Project Name: Wayne State University
Football Stadium Elevator
Adams Field
Detroit, Michigan

Addendum Number: 4

Date: 1/2/2020

Addendum Number: 4

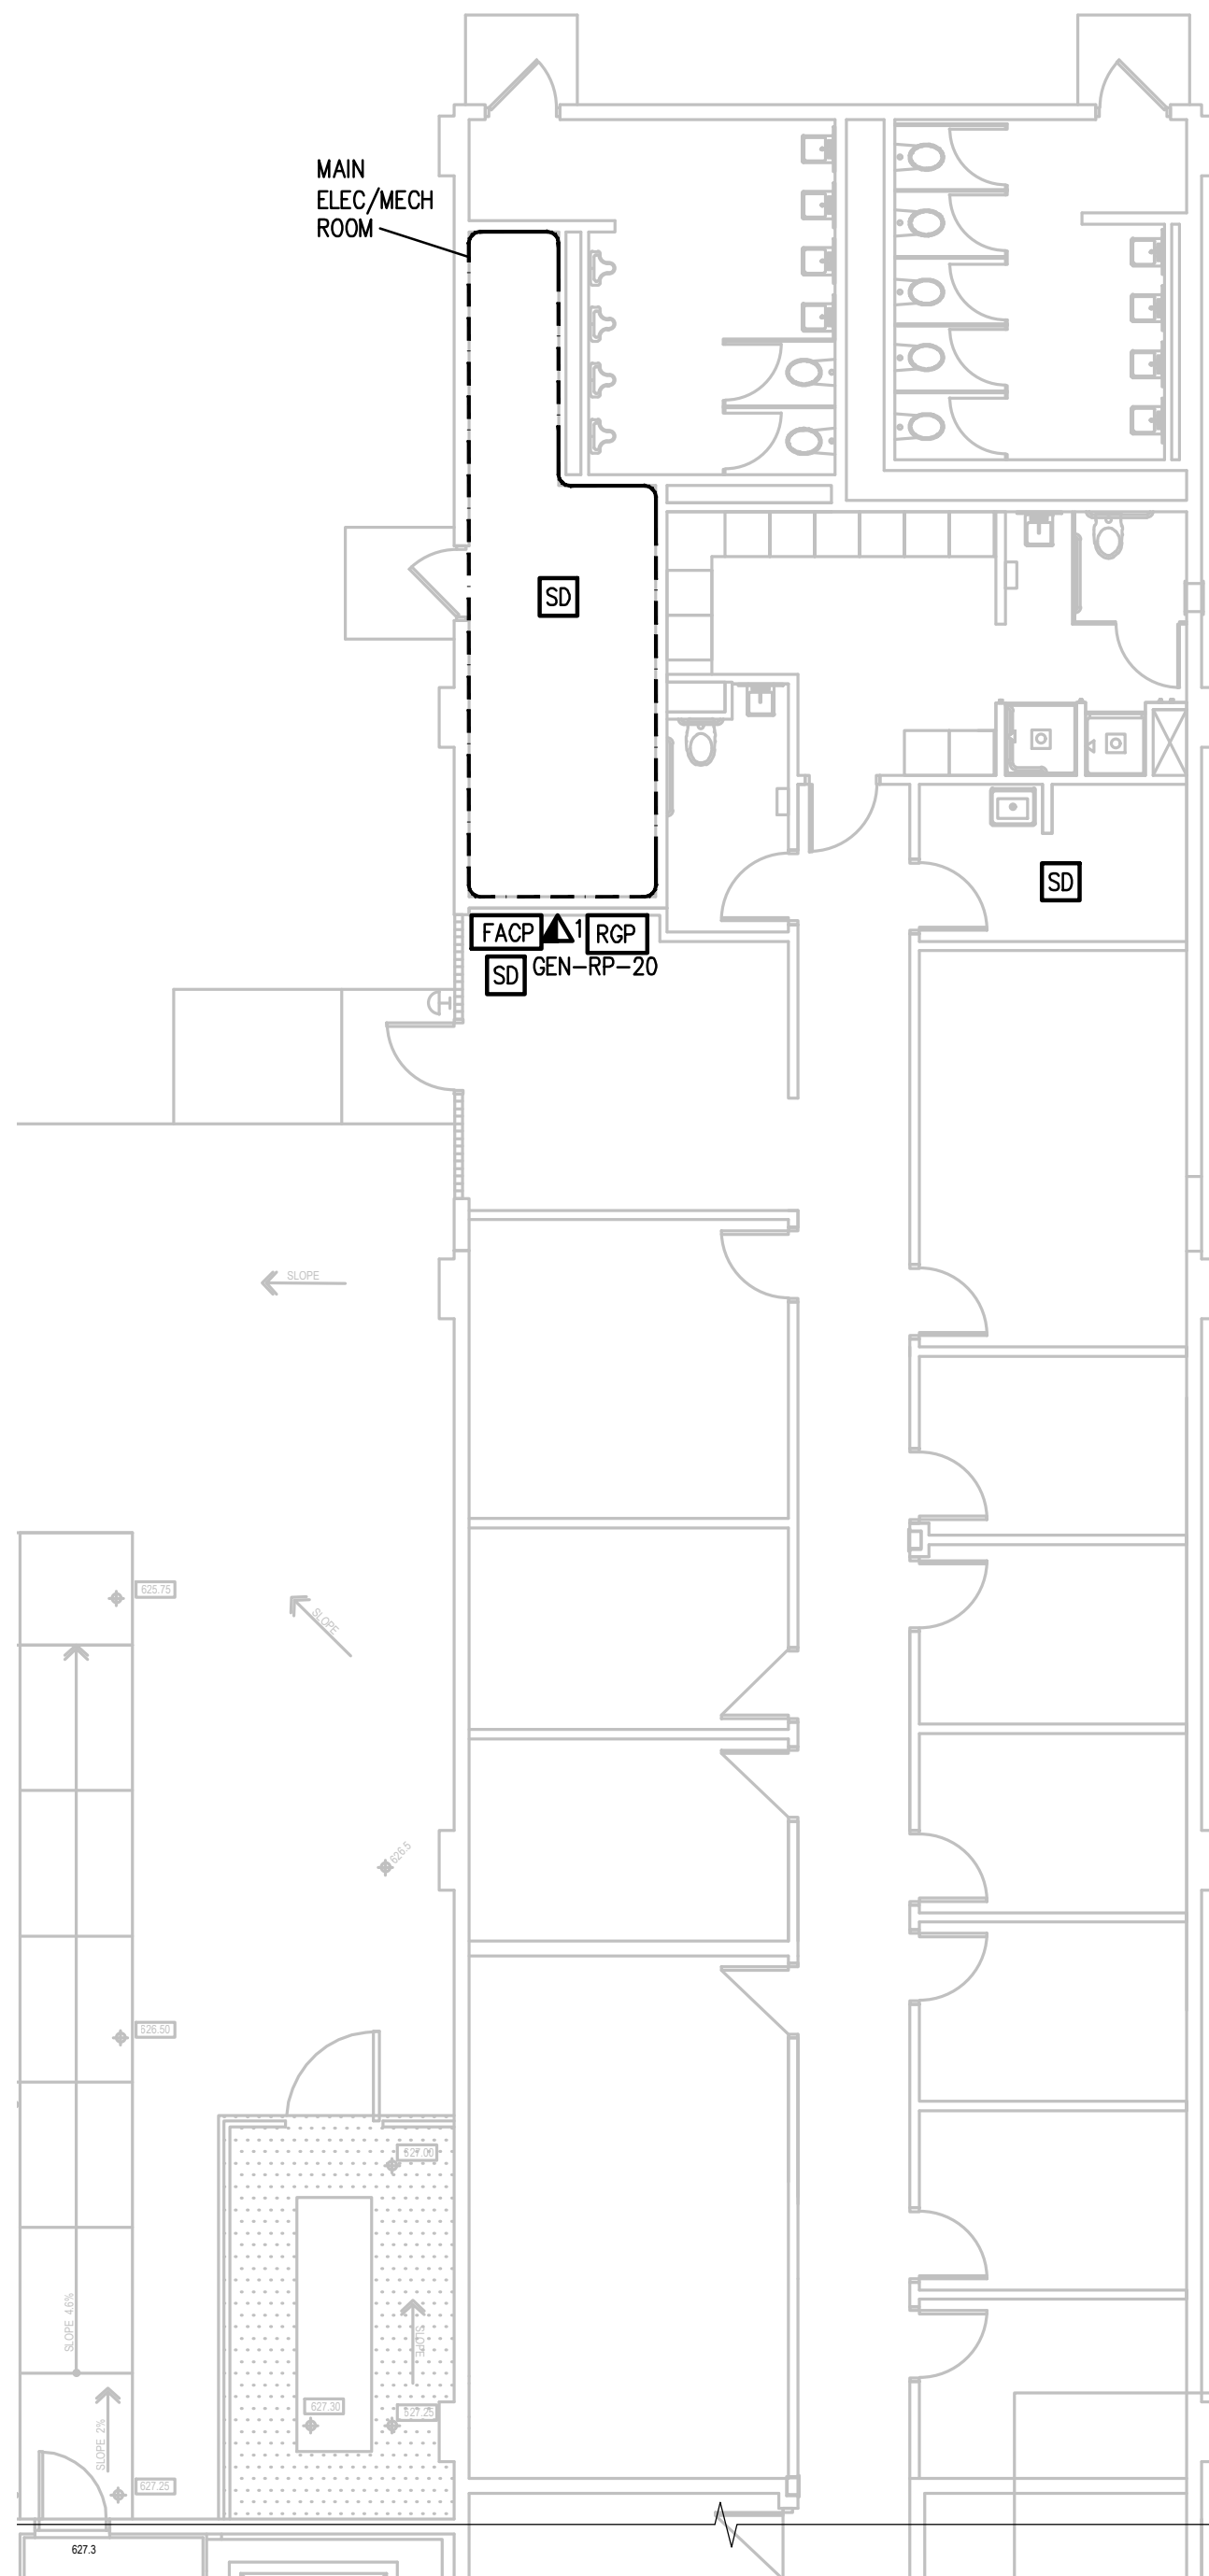
Architectural Drawing Items: Refer to Sheet A.21
1. Louver opening as indicated.

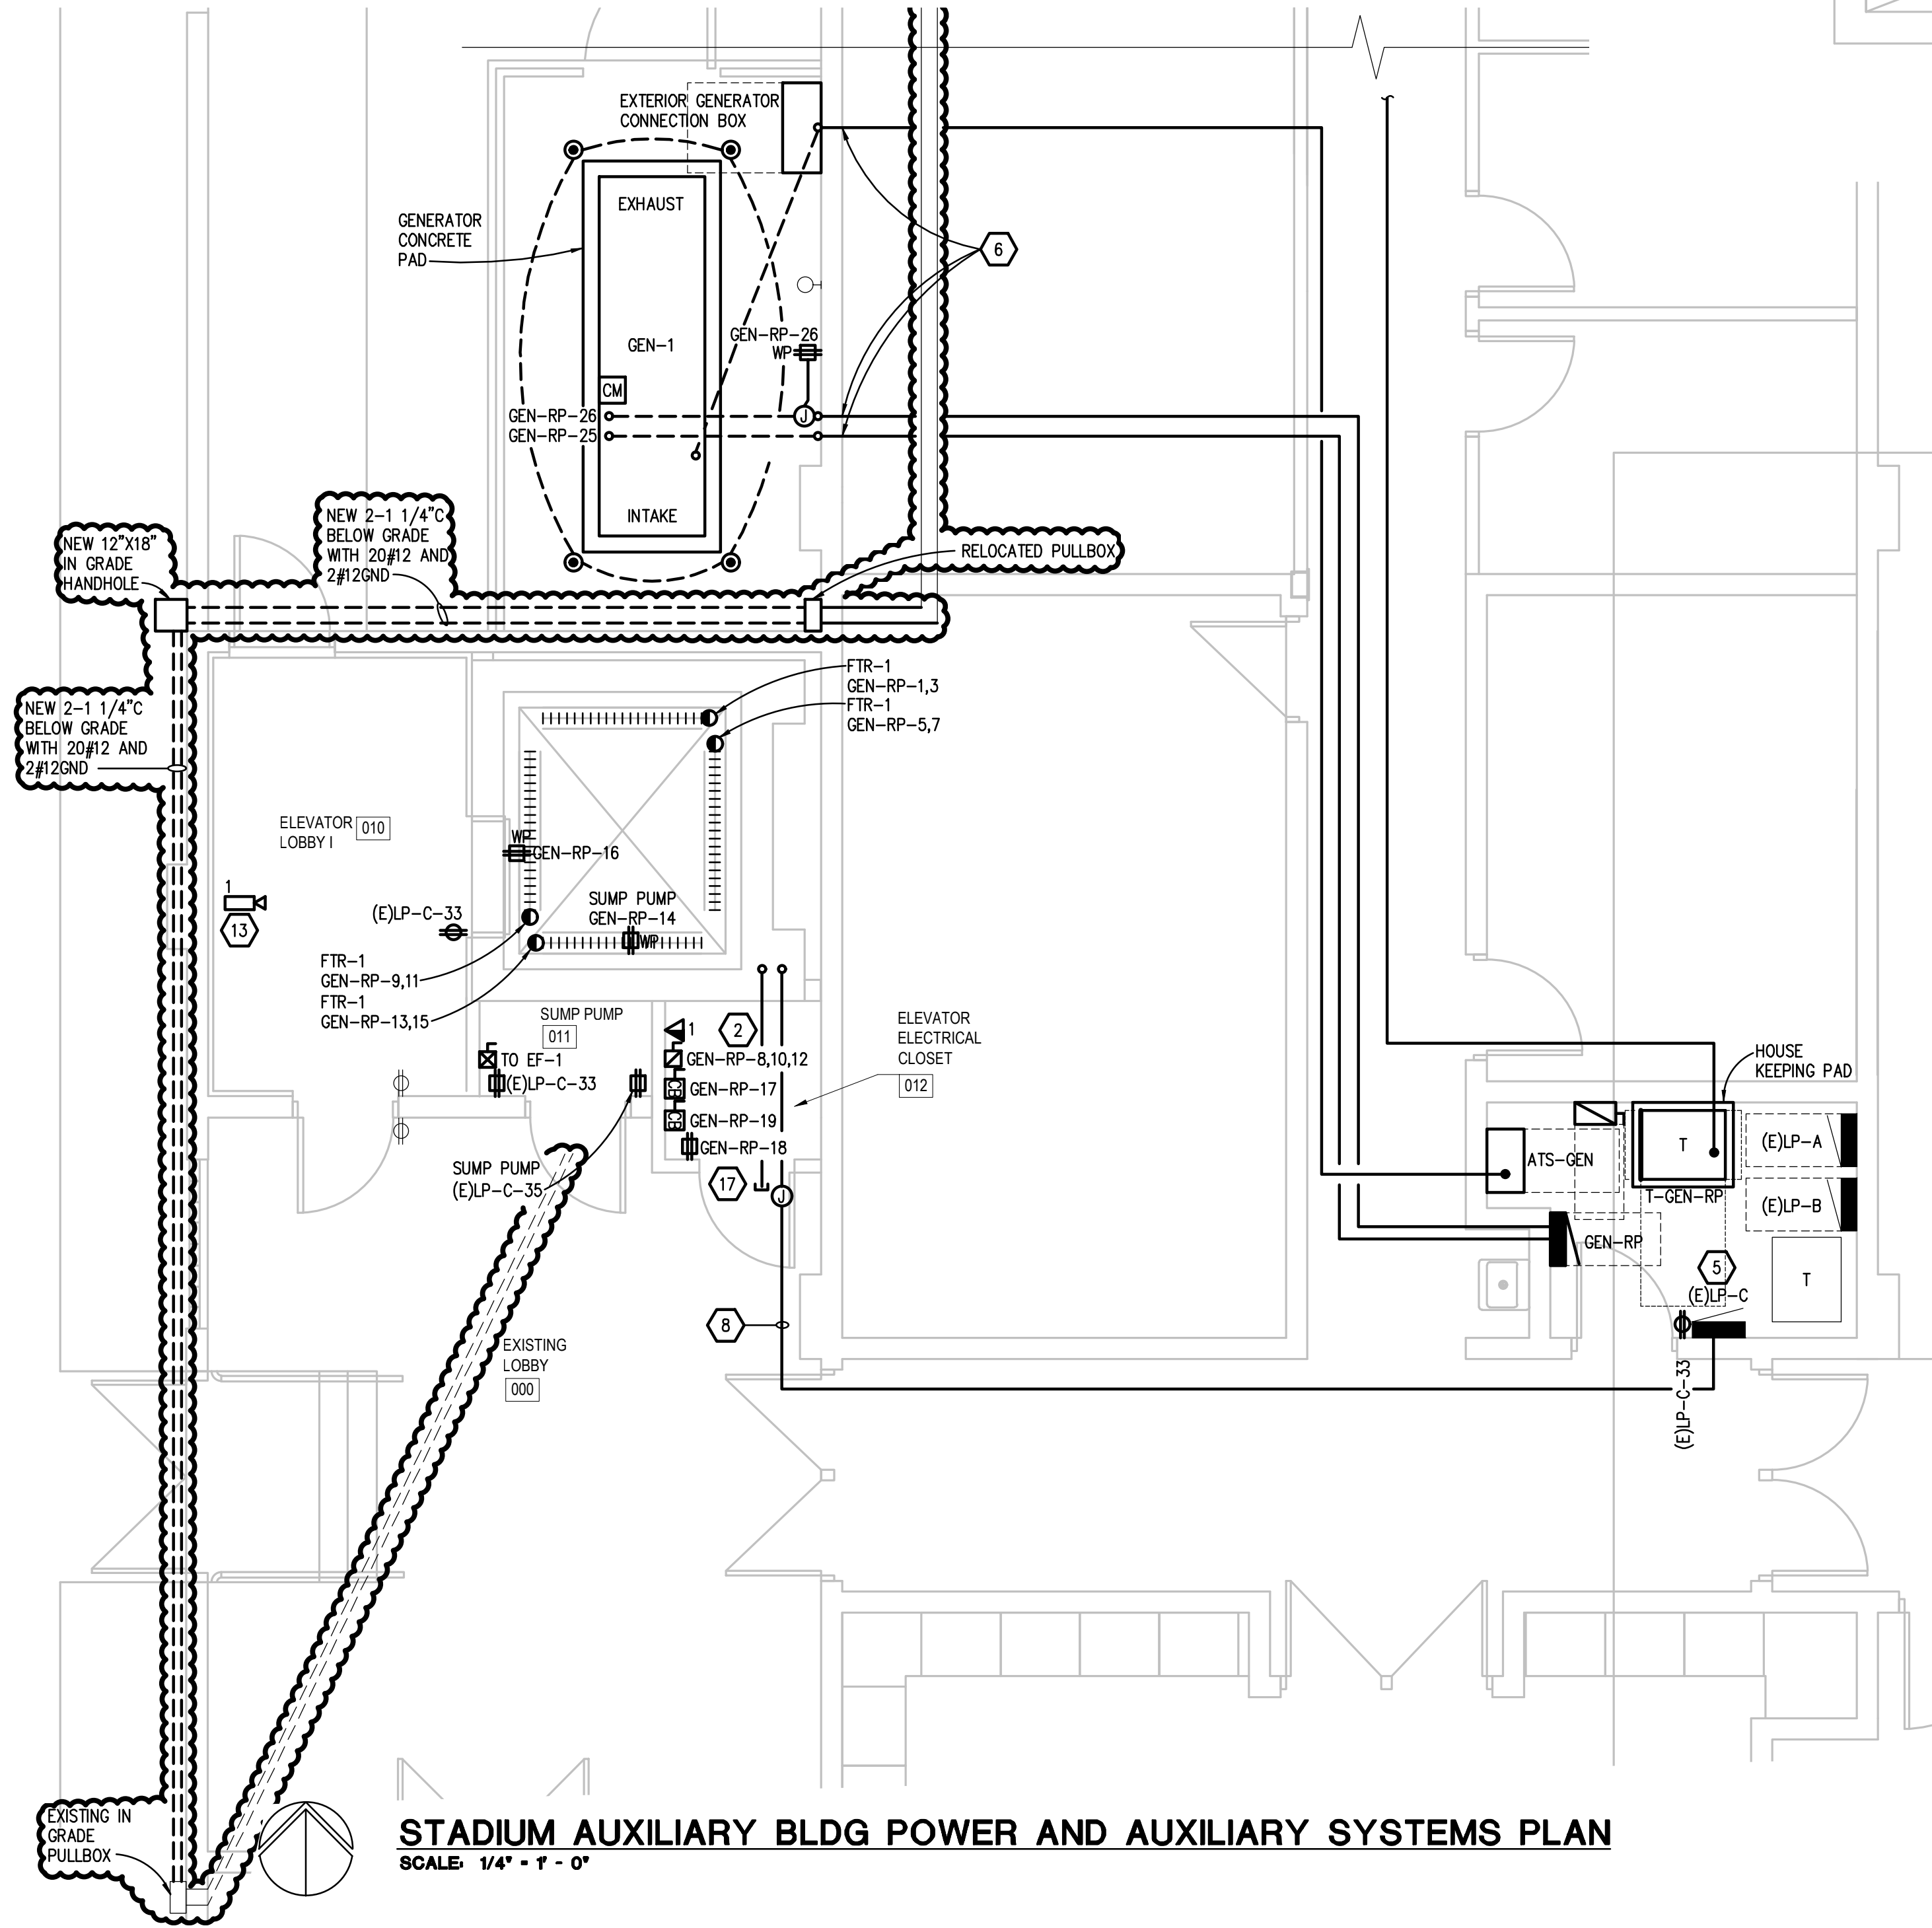
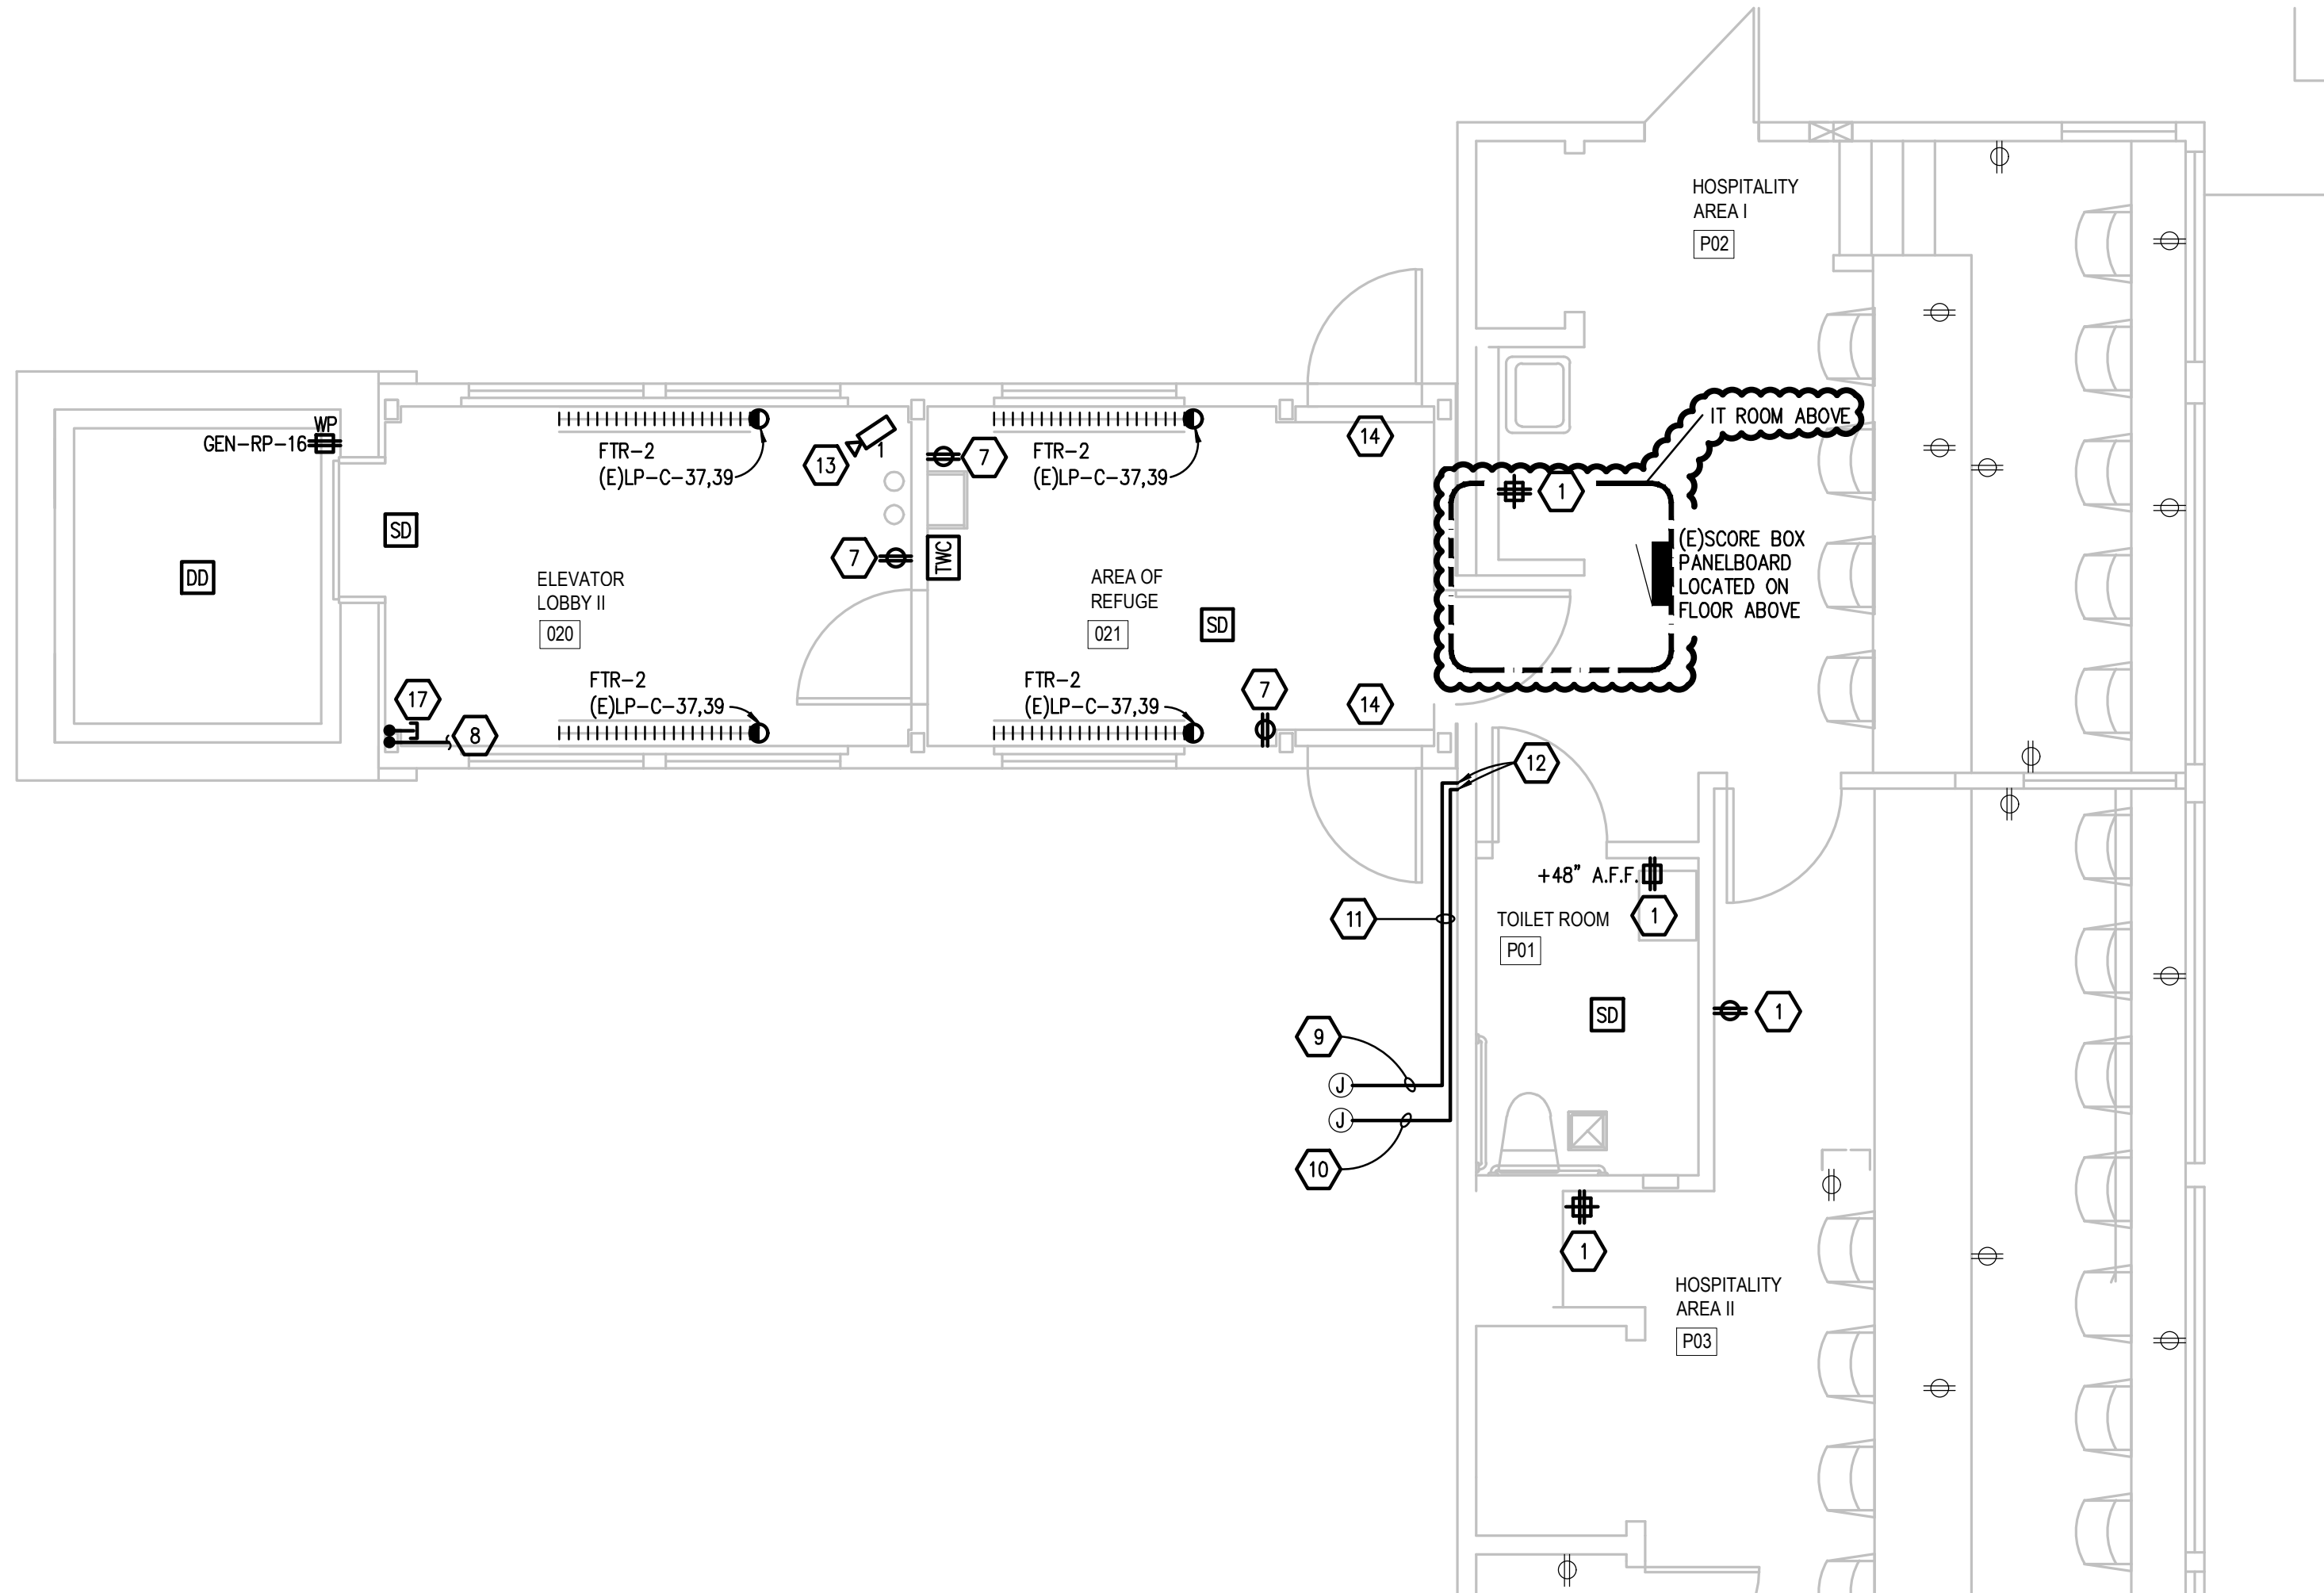
1. Added NEMA 3R box as indicated.
2. Added conduit as indicated.
